MEMORANDUM

SUBJECT: Staff Analysis of the "Edgewater Conceptual Plan" -
CP 89-C-025

EDGEWATER
CONCEPTUAL PLAN
 FAIRFAX COUNTY, VIRGINIA
 HUNTER MILL DISTRICT
 RESTON SECTION 931 BLOCK 4
 RESTON LAND CORPORATION

Edgewater Conceptual Plan

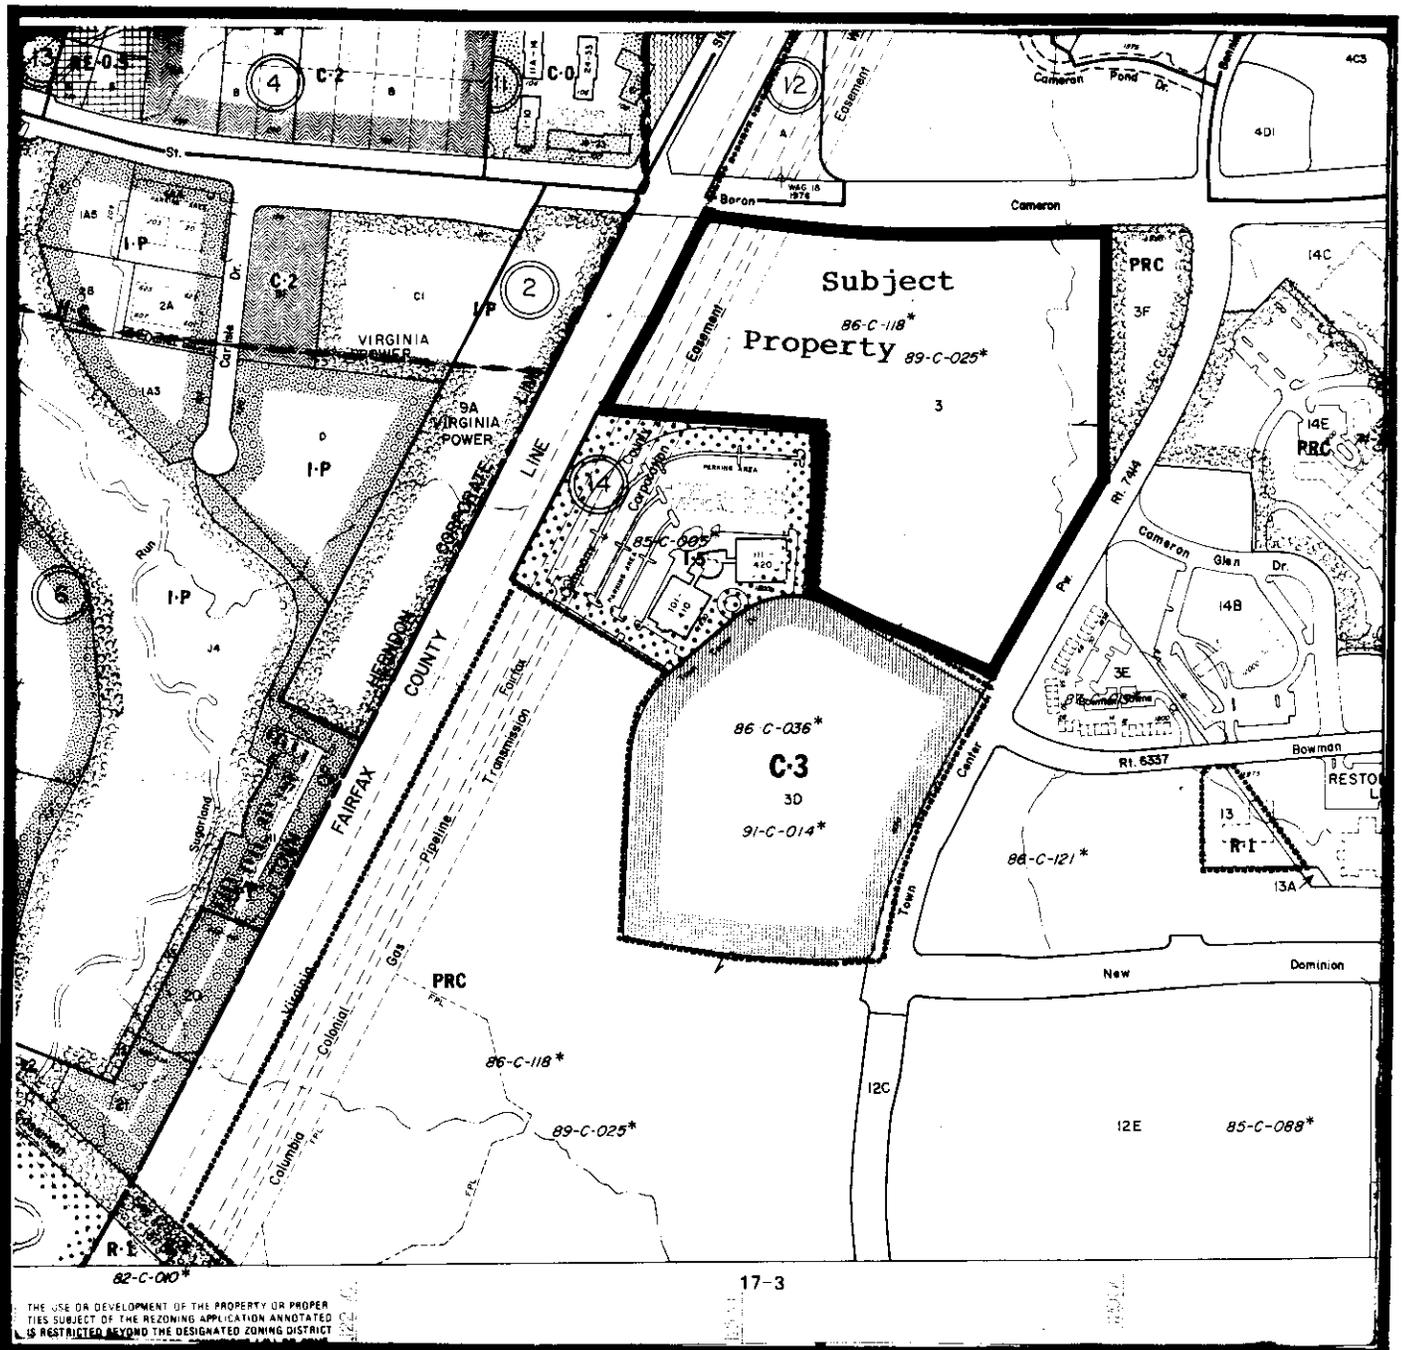
The proposed development plan includes residential units that will be affected by high exterior noise levels generated by traffic on Fairfax Parkway, Cameron Avenue and possibly Town Center Parkway. All units that are adjacent to and not shielded from these roadways will be impacted by highway noise. Noise mitigation should be provided to ensure that interior noise levels will not exceed 45 dBA Ldn and exterior noise levels in privacy yards not exceed 65 dBA Ldn.

The residential units along the western boundary near the Fairfax Parkway are in close proximity to a major gas transmission easement. Units 5, 7, and 9 are closest to the easement. These units should set back from the centerline of this pipeline as a precaution.

The development plan notes that 10% minimal tree cover will be provided and that tree save areas are conceptual and will be modified. This is a residential area and more tree cover should be provided to ensure that the coverage is consistent with the density recommendations of the tree cover ordinance and to restore meaningful amounts of tree cover lost to site development.

The applicant needs to mitigate the impact of the hospital and related facilities upon the proposed townhouses to be located along the eastern portion of the western and southern boundary of the site.

The applicant should provide better buffering and screening along the eastern portion of the western and southern boundary of the site where the proposed townhouses will be located. Plantings should include a mix of evergreen and deciduous plants.

The first row of townhouses, along Town Center Parkway, is visually impacted by its close proximity to the proposed clubhouse.

Provide more screening to protect the privacy yards of the first row of townhouses closest to the proposed clubhouse.

The proximity of the multifamily structure #5 is too close to the Baron Cameron Avenue right-of-way. Also multifamily structure #9 is too close to a future public street right-of-way (Fairfax County Parkway). There is nothing to buffer these multifamily structures from the impact of these existing and future major roadways.

Relocate multifamily structures #5 and #9 away from the right-of-ways that abut their proposed location. Provide a buffer and screening to mitigate the impact from these existing and future roadway right-of-ways.

The western portion of the southern boundary of the site where the multifamily structures are located is not adequately buffered and screened to mitigate the visual impact of the hospital and related offices as well as large parking areas that abut to the south.

Provide buffering and screening along the western portion of the southern boundary of the site where the multifamily structures are located.

No parking is provided at the clubhouse.

Provide parking at the clubhouse for residents.

The issues of highway noise mitigation and building setback from existing utility transmission lines which are raised in the environmental comments, Attachment 6, have been satisfactorily addressed by the applicant. Note Number 11 states that highway noise mitigation will be provided to ensure that interior noise levels will not exceed 45 dBA Ldn and exterior noise levels in privacy yards will not exceed 65 dBA Ldn. As shown on the plan, proposed buildings #4 and #8 are set back a minimum of 50 feet from the closest utility transmission line, a distance which is a staff recommended guideline. Regarding tree preservation, tree save areas are shown on the concept plan. However, Note Number 15 states that the tree save areas shown on the plan are conceptual and subject to adjustment during the final engineering process. To tighten the commitment to tree save on the property, staff recommends that approval of the Conceptual Plan be contingent upon the provision of the tree save areas as shown on the Plan.

Note Number 14 on the Conceptual Plan states that a landscape plan will be submitted with the Preliminary and Final Site Plans that meets the tree cover requirements, as specified in the Zoning Ordinance, and is consistent with the "Reston Town Center Urban

Design Principles". The Reston Town Center proffers require approval of all landscape plans by the County Urban Forester and the Reston Town Center Architectural Review Board. Staff recommends that on the final site plan, particular emphasis be placed upon the provision of landscaping along the property boundaries.

The setback between proposed building #7 and Baron Cameron Avenue has been increased to 35 feet. Note #16 states that ten (10) 18-22 foot tall Leyland Cypress trees will be installed in the setback area. The setback between proposed building #4 and #8 to the closest existing utility pipeline has been increased to fifty (50) feet, a setback recommended by staff.

The revised plan shows parking for the pool/clubhouse located to the east of the facility.
